Product Change Notification / CENO-23PKZQ392

CCB 6062 Initial Notice: Qualification of EN4900G as a new die attach material for KSZ8041TL, SPNY801037, KSZ8041FTLI, KSZ8041TL-TR, SPNZ801037-TR, and KSZ8041FTLI-TR catalog part numbers (CPN) available in 48L TQFP (7x7x1.0mm) package.

CCB 6062
Pre and Post Change Summary
PCN #: CENO-23PKZQ392

Pre Change

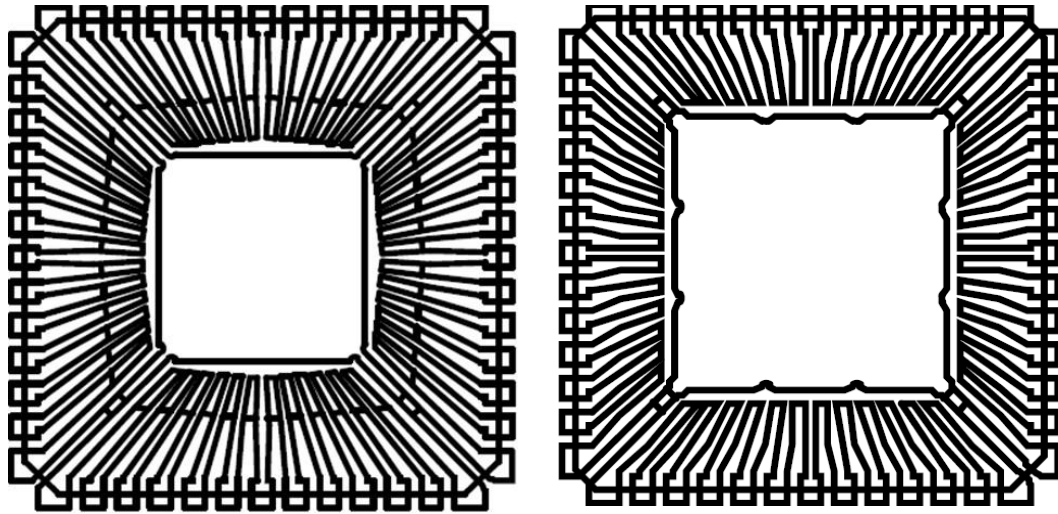
LEAD FRAME COMPARISON

Lead frame Material	C7025
Lead frame Paddle Size	120x120 mils

Lead frame Material	C7025
Lead frame Paddle Size	160x160 mils

Post Change

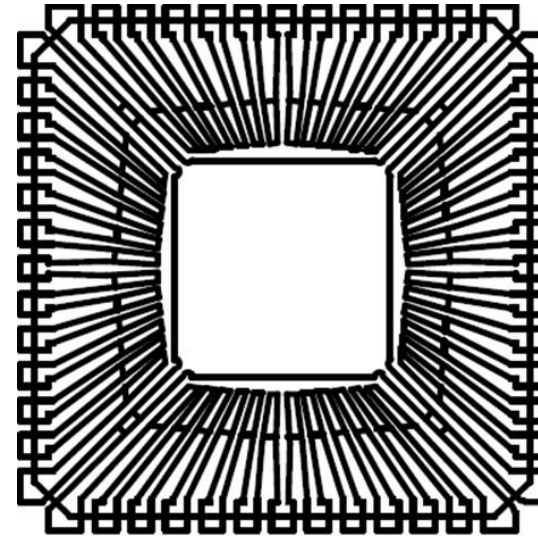
Lead frame Material	C7025
Lead frame Paddle Size	120x120 mils
